Addendum	03
Date:	August 13 th , 2026
Project:	KGCC - Clubhouse
Address:	777 Clonsilla Av. Peterborough ON

1 INTENT

1.1. This Addendum is issued prior to receipt of Bid to provide clarifications and revisions to the Drawings and Specifications. Receipt of Questions. The following additional instructions shall apply to and govern the Bid Documents.

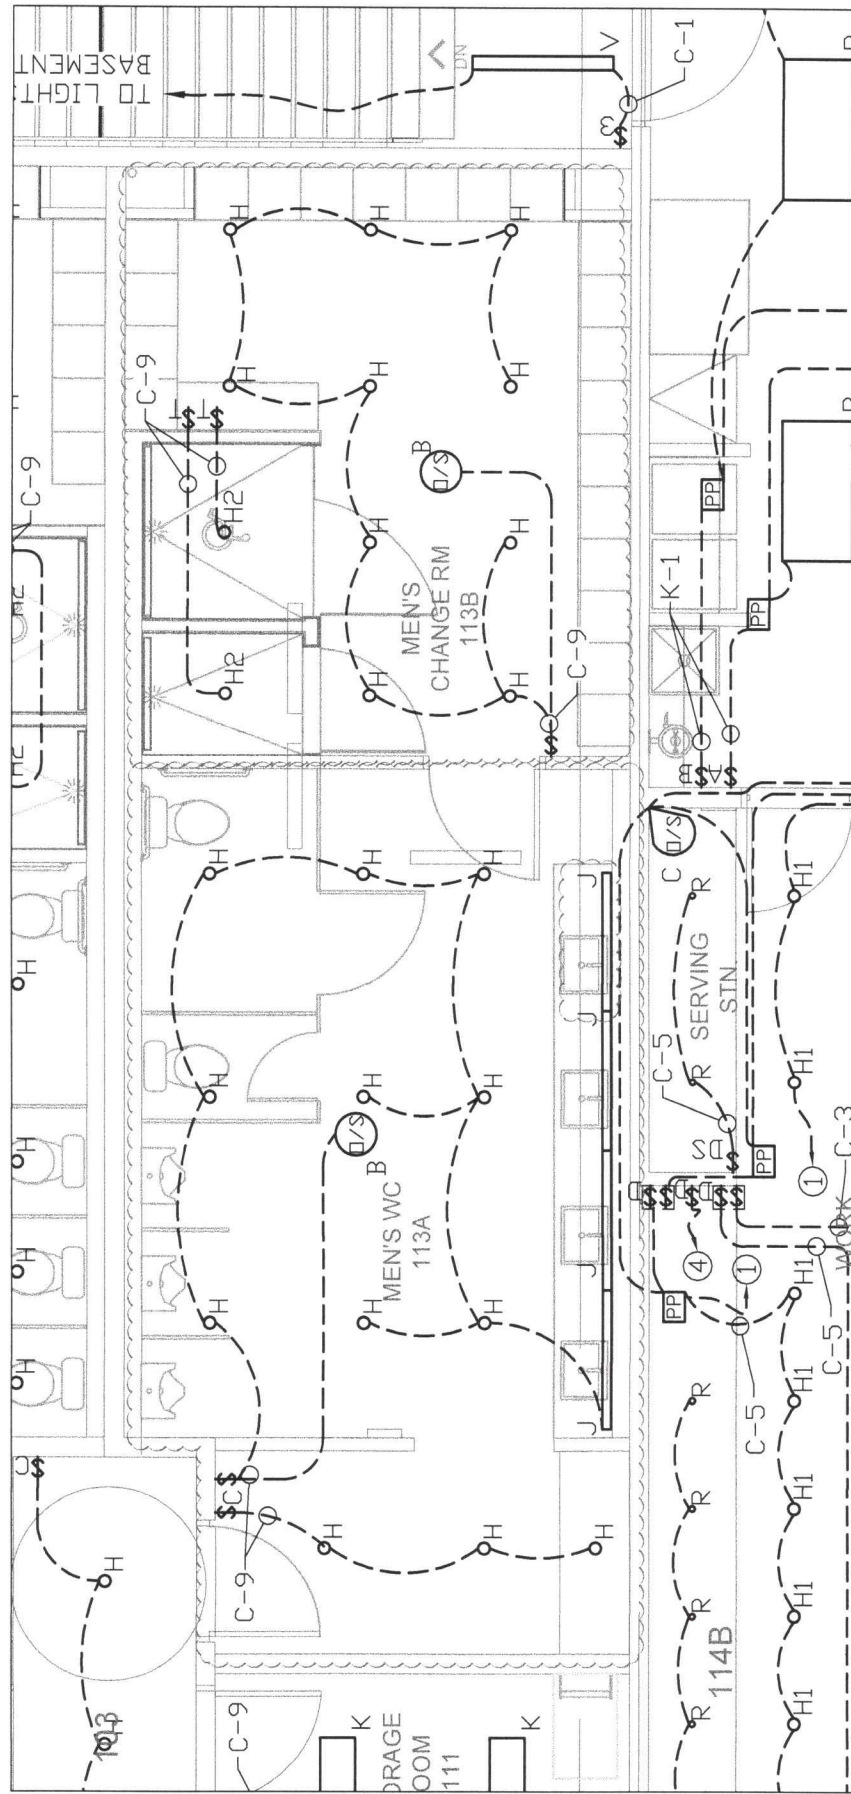
1. The two (2) type 'H2' lights in the Men's Change Room 113B shall be relocated so that one (1) is in each shower. The timer switches that control each light shall be relocated to the outer wall of the second shower stall. See Sketch SK-E1.
2. Relocate the switch into the Men's Change Room. Relocated two (2) type 'H' lights into the Men's Change Room 113B. See Sketch SK-E1.

3. Lights in Men's Washroom 113A have been rearranged. See Sketch SK-E1.
4. Add one (1) new type 'J' fixture above the sink in Men's Washroom 113A. See Sketch SK-E1.

GROUND FLR PLAN

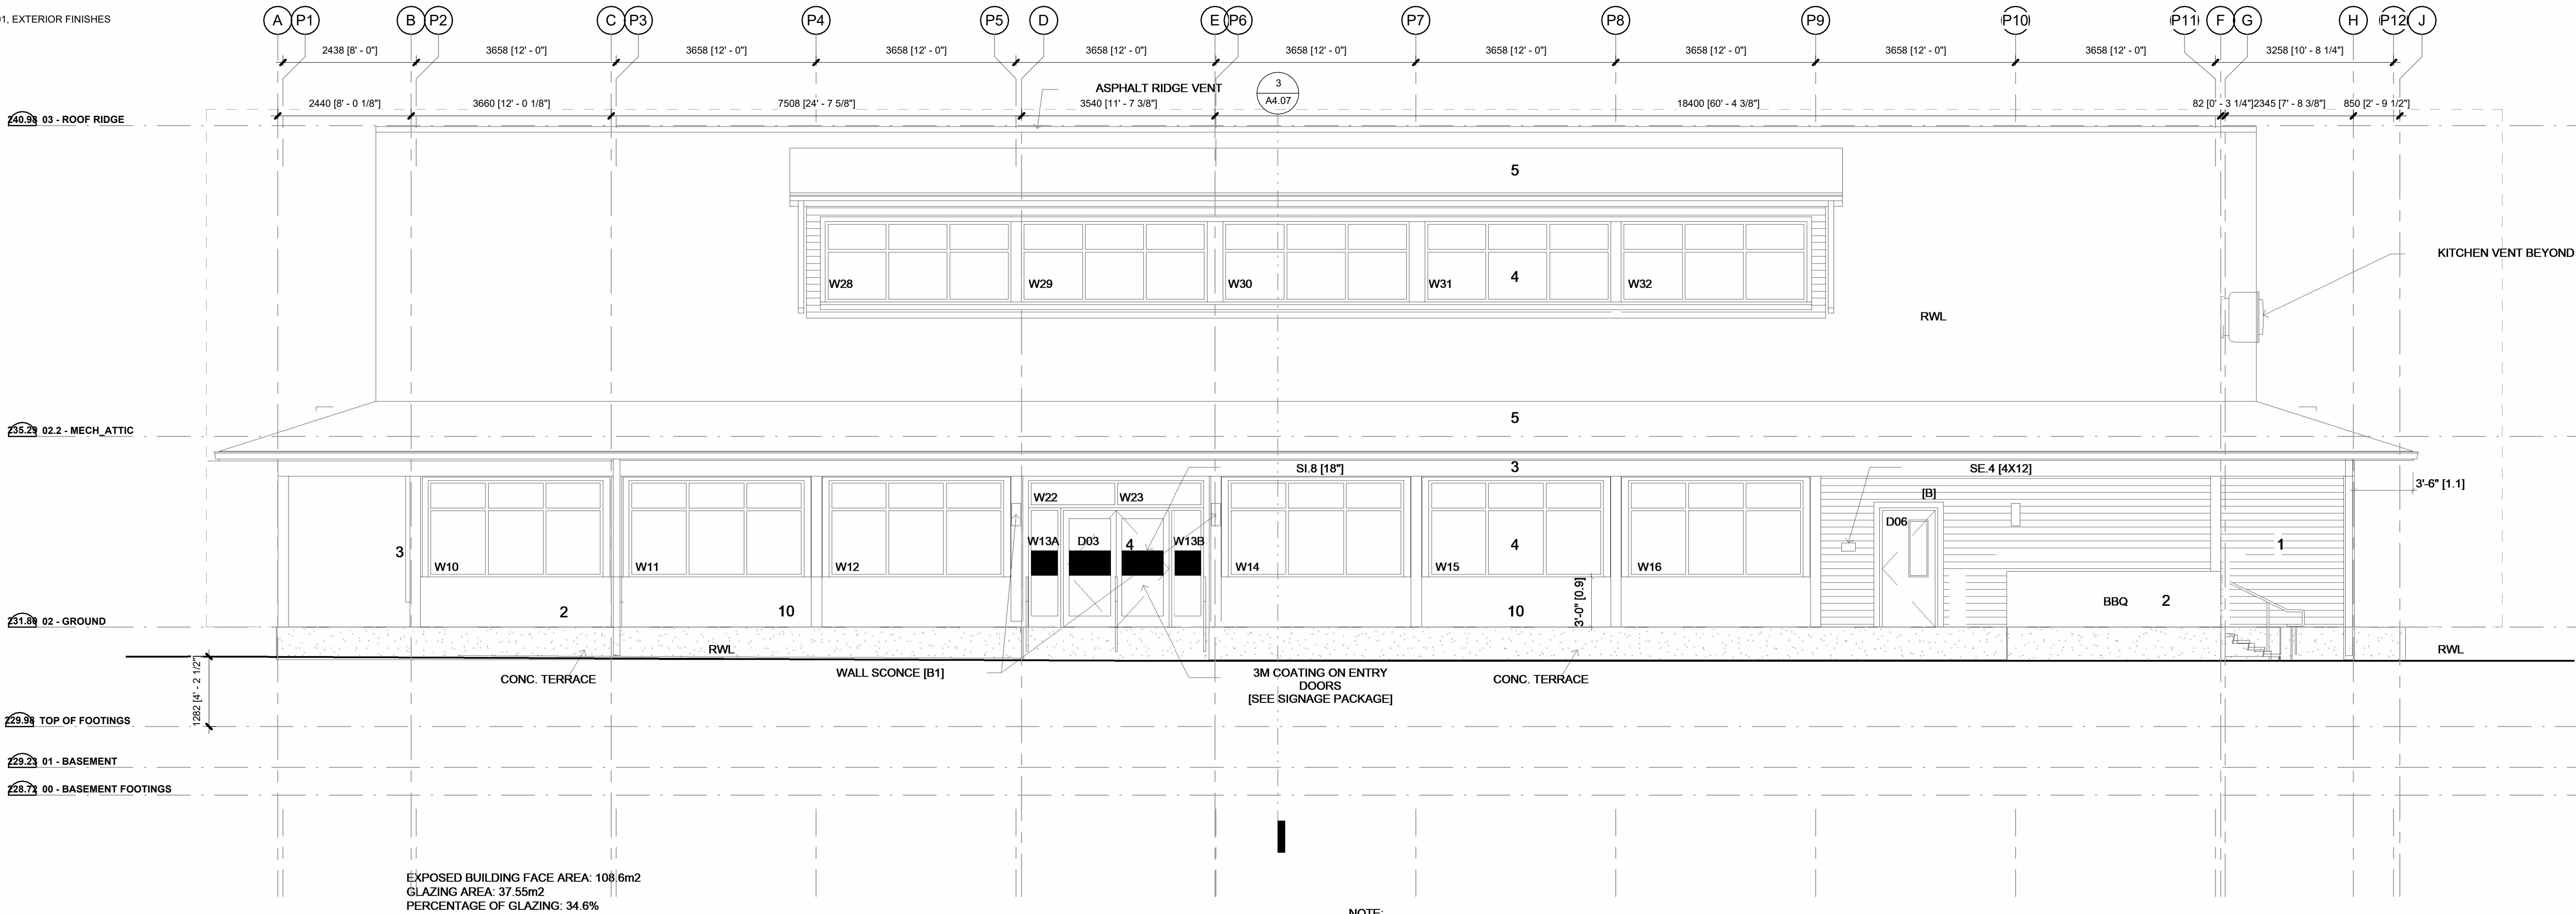
64. Please confirm size of W05 - Window Schedule A8.00 does not match Elevation A3.01 or the ground floor plan on A2.03 *See Addendum 02 regarding window pricing – updated information to be provided in IFC*

Drawing title:
Sheet no:
A3.00

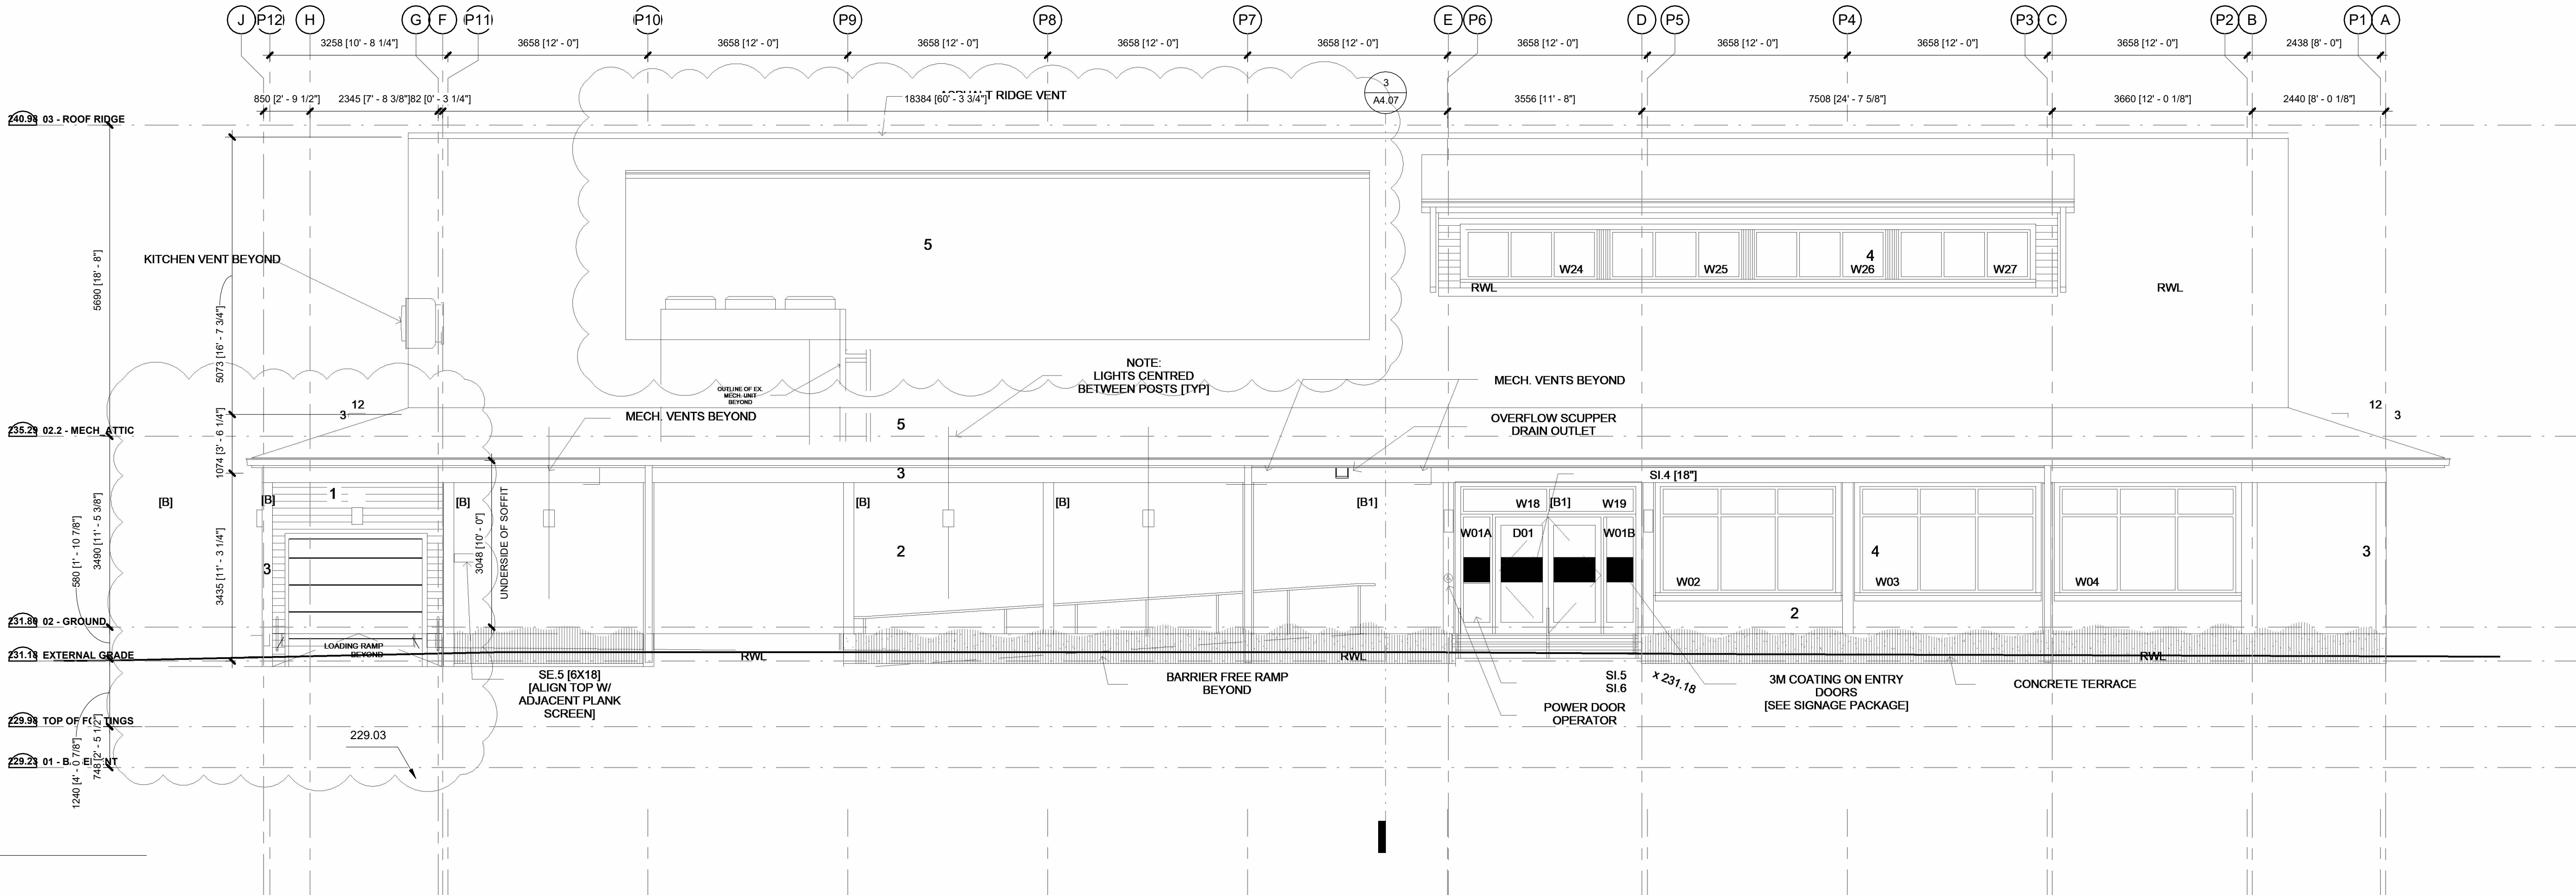
46. **Drawing A3.00 Detail #1 identifies the ridge vent as asphalt, can we use Cobra or equal?** *Rapid ridge vent specified on A5.03/7 <https://benjaminobdyke.com/product/rapid-ridge-ridge-vent/>*

54. **Drawings A3.00 and A3.01 (Material Legend) - both state to refer to architectural Appendix 01, exterior finishes. Per the provided list of bid documents, Appendix 01 is listed as Millwork. Please clarify. Refer to Appendix 02.**
